Fairfield Ludlowe High School Ventilation Study Issues Resolution

for
Fairfield Public Schools
Fairfield, CT

March 2, 2021

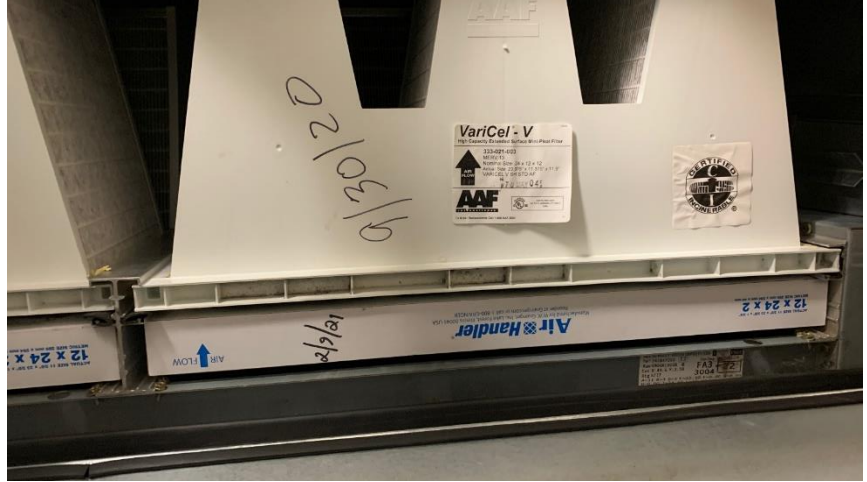
Item ID	Unit	#	Comment	IAQ or Maint.?	vZ Response	Picture
10	AHU-16	3	Is there more than one filter? If so, were all of them changed?	IAQ	4x 2" MERV 13 filters were installed 2/9/21.	
11	AHU-16	4	Was/were any new filter(s) installed? If so, what type was/were installed on 9/11/20?	IAQ	Yes, and they were replaced again on 2/9/21, see above.

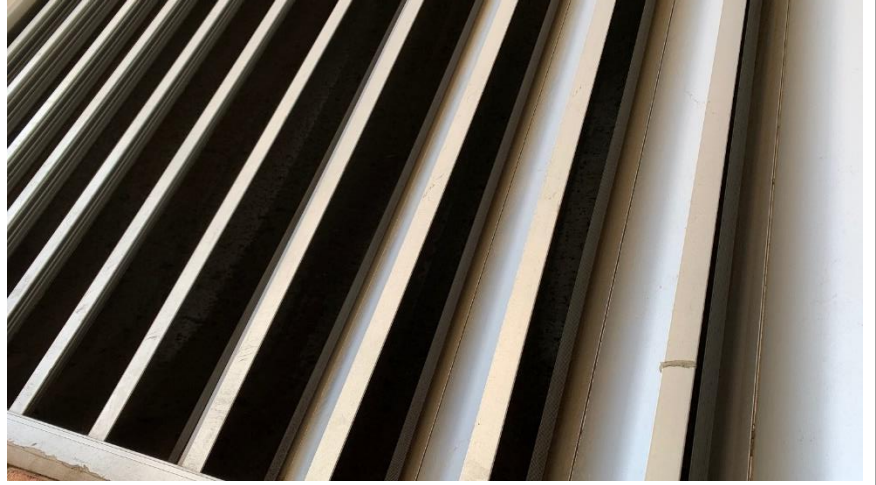
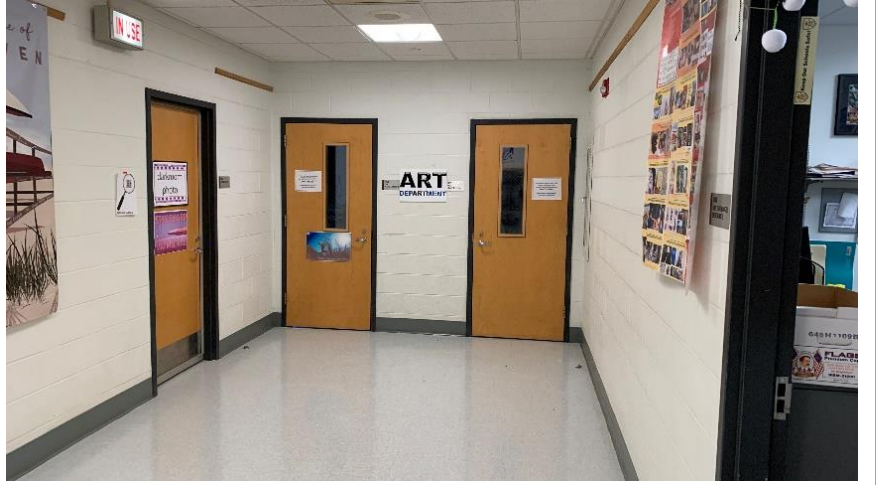
Item ID	Unit	#	Comment	IAQ or Maint.?	vZ Response	Picture
12	AHU-17	1	Insulation was replaced at appropriate locations (ductwork)?	Maint.	Yes, insulation was repaired or replaced.	
13	AHU-17	2	Coil was cleaned?	IAQ	Yes, the coil was cleaned.

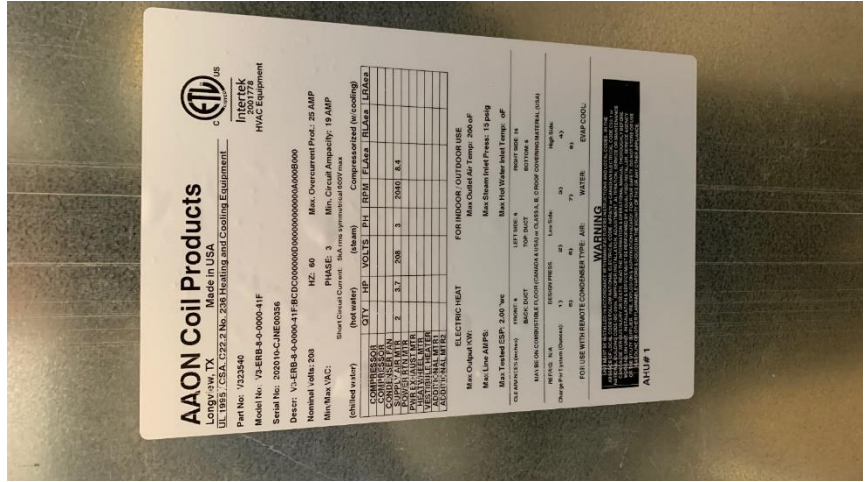
Item ID	Unit	#	Comment	IAQ or Maint.?	vZ Response	Picture
14	AHU-17	3	Was unit and squirrel cage cleaned of debris, dirt, and insulation?	IAQ	Yes, the cage and unit were cleaned.	
15	AHU-17	4	Is there more than one filter? If so, were all of them changed? What type was/were installed on 9/11/20?	IAQ	4x 2" MERV 13 filters were installed 2/9/21.
